# SERVICE BULLETIN

M-986

September 15, 1989

## 1340cc CLUTCH PUSH ROD ADJUSTING STUD (ADJUSTER SCREW)

Figure 1. 1340cc Clutch Adjuster Screw End Comparison

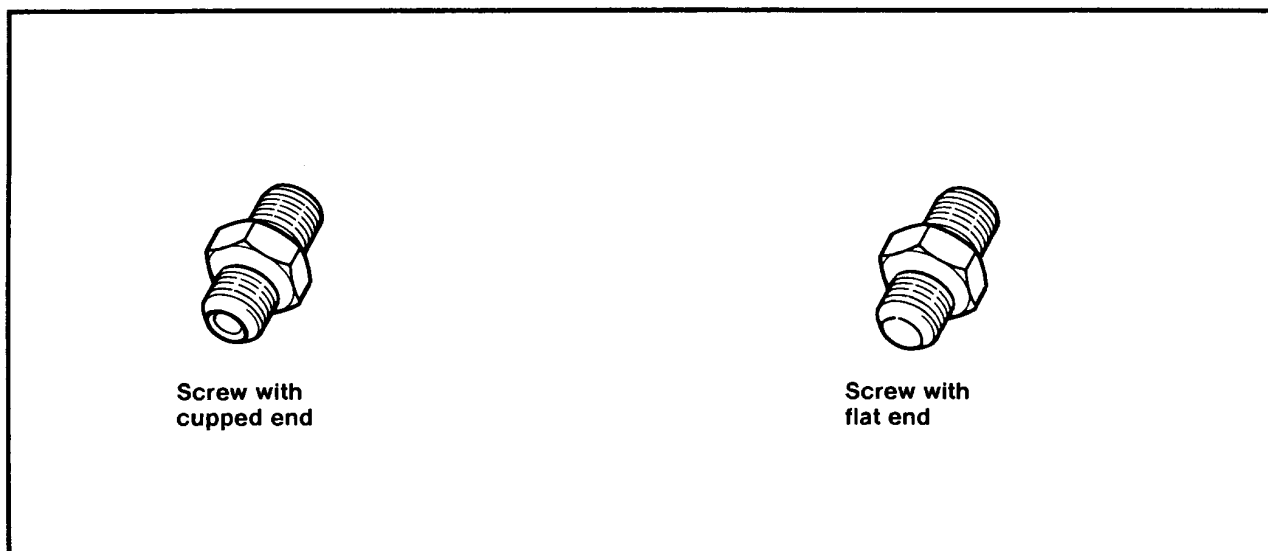
See figure 1. From 7/10/89 to 7/29/89 an unknown quantity of 1989 and 1990 1340cc motorcycles were manufactured with a clutch push rod adjusting stud (adjuster screw) that was "cupped" at the push rod end.

Friction forces resulting from the cupped end create the potential for push rod bearing failure.

The symptom for push rod bearing failure will be excessive freeplay at the clutch lever.

When your 1340cc motorcycle customer comes in for his 500 mile check-up, inspect the push rod adjusting stud and if it is cupped, replace the cupped stud with a flat ended stud, Part No. 37357-84.
